# Los Angeles International Airport

## 14 C.F.R. Part 161 Application for Approval of a Runway Use Restriction Supplemental Analysis

June 2013

**Figure S-17 Non-Conforming Operations from Year 2001 through 2012**

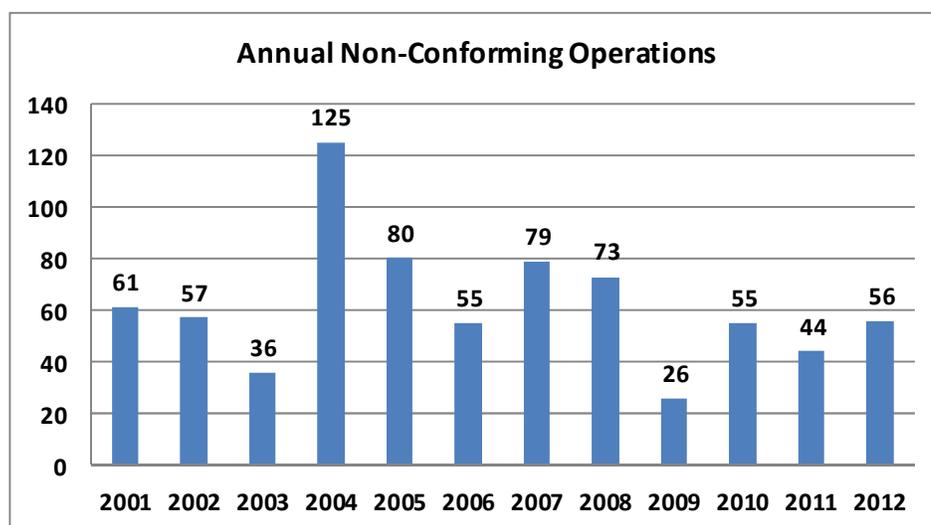
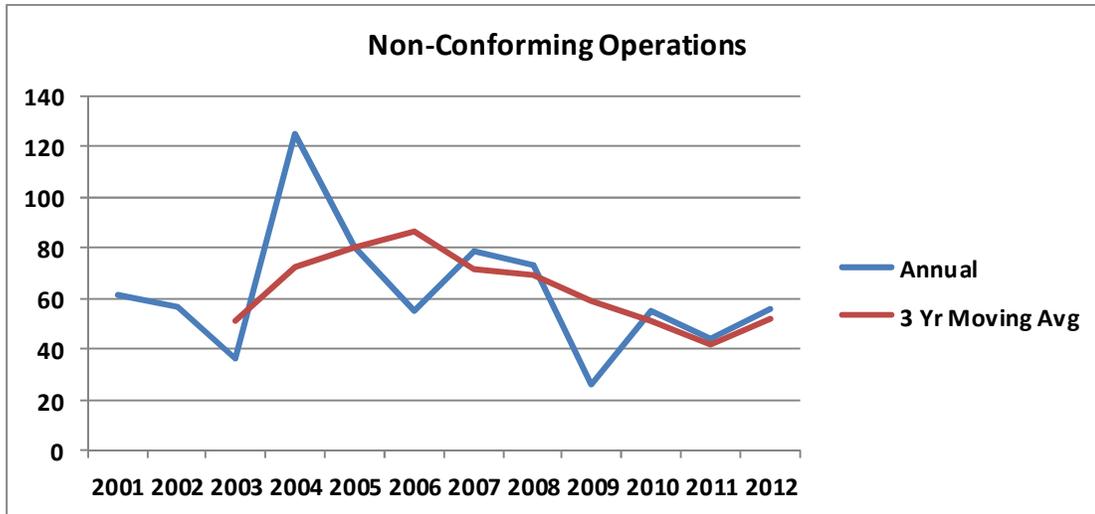
FAA Comment: *If benefits are qualitative, a discussion is needed for each offsetting cost on operators, airports, passengers, and cargo. A more rigorous approach to forecasting nonconforming departures should be used including moving average; last observed year; historic*

***average; and regression with independent variables (such as time, operations, pacific rim departures, and wind).***

Figure S-17 shows annual non-conforming operations from 2001 (the first full year for which data are available) through 2012. The number ranges from a high of 125 in 2004 to a low of 26 in 2009.

The forecast value of 65 per year is based on the average for the years 2001 to 2010, the data available when the forecast was prepared. Total non-conforming operations were below average in 2011 and 2012, while an unusually high number of 12 non-conforming departures were recorded in January 2013, possibly presaging an increase for the present year. The average for the 2001-2012 time periods is 62 per year, and the average for the series minus the high and low years of 2004 and 2009 is 60 per year.

Figure S-18 compares annual non-conforming operations to a three-year moving average of operations. Smoothing the highs and lows, the chart shows a gently downward trend through 2011 followed by an uptick in 2012.

The option of using regression analysis to prepare a forecast was explored but found not suitable for several reasons. As the charts above show, the number of non-conforming operations shows very large year-to-year changes, with the absolute value of year-to-year changes averaging 56.7% from 2001 to 2010. None of the logical explanatory variables such as total air carrier departures, heavy aircraft departures, or departures to Asia and Australia/New Zealand has comparable year-to-year changes. Any association between these variables and non-conforming operations would produce a misleading forecast model because it would indicate that a small change in one or more of these classes of departures would cause a very large change in non-conforming operations. In econometric terms, this type of finding would show correlation but would not indicate causation, and would be unsuitable for forecasting.
